Arboricultural Consultation Response

Application No: 25/00943/HHFUL	**Location:** Ganymede, High Haden Road, Glatton, Huntingdon, PE28 5RU
Case Officer: JFR	**Proposals:** Outbuilding to form garden room, store and home gym

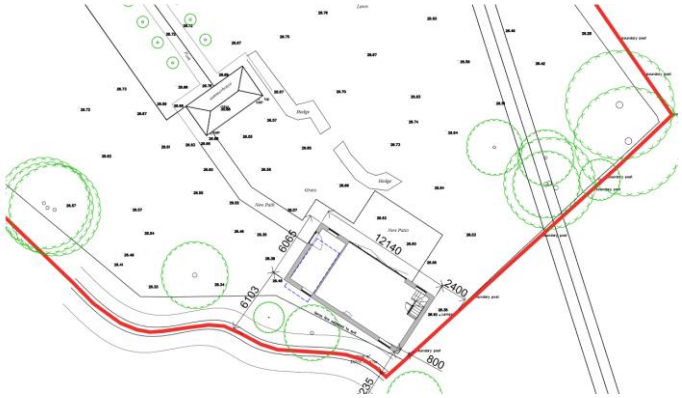
There appears to be a large number of individual trees and woodlands on site that would require consideration in the planning process. Although several trees are shown on the mapping provided it is clear there is a large group of trees in the location where the proposed building is to be located.

No AIA, Tree Protection Plan or Tree Survey has been provided with the application so it is not possible for me to make an assessment on the impact to existing trees, their Root Protection Areas or Canopy spread, both now and in the future. It appears from the drawings that the building is a significant construction located close to mature trees, as such it is likely that pressure for removal and pruning would be exerted. It is also likely that the building will be shaded for an extensive part of the day.

It is necessary to demonstrate that the development will not impact the trees located nearby, and without the necessary information doing this, it is not possible to support the application.

Recommendation: Refuse Application subject to receipt of an BS5837:2012 Tree Survey, AIA, TPP and Method Statement.
